ADDENDUM #3

Utqiagvik Courthouse Upgrades Bid Package PROJECT #UTQ-C-25-0015

Date: **September 11, 2025**

C1 ENLARGED PLAN - SUPERIOR COURT 201 JUDGE/CLERK BENCH

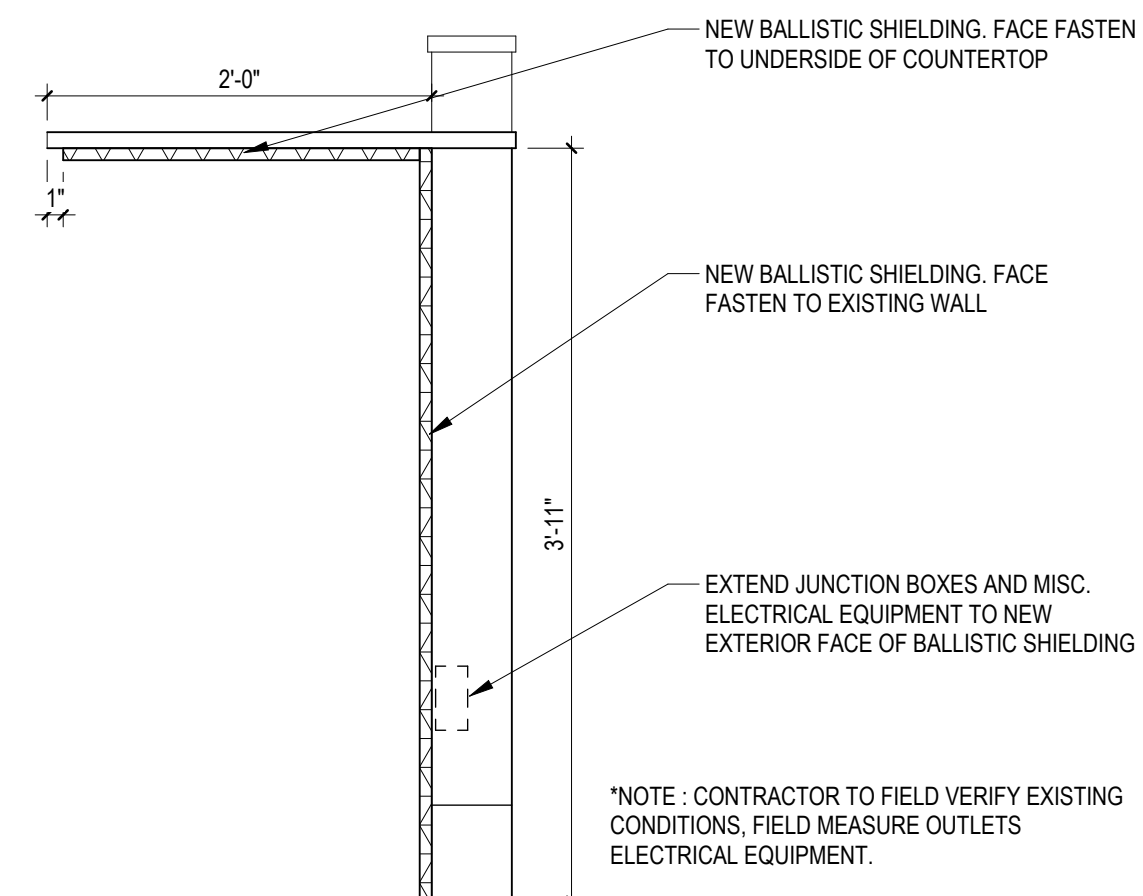
6. C1/A105 shows a dashed line. A1/A105 does not show a dashed line. The legend does not indicate what the dashed line is for. Please advise what the dashed line is for and if it should also be applied to A1/A105. **Answer: The dashed line indicates the location of the ballistic shielding installation. The drawing has been revised to show it applying to A1/A-105 (attached).**
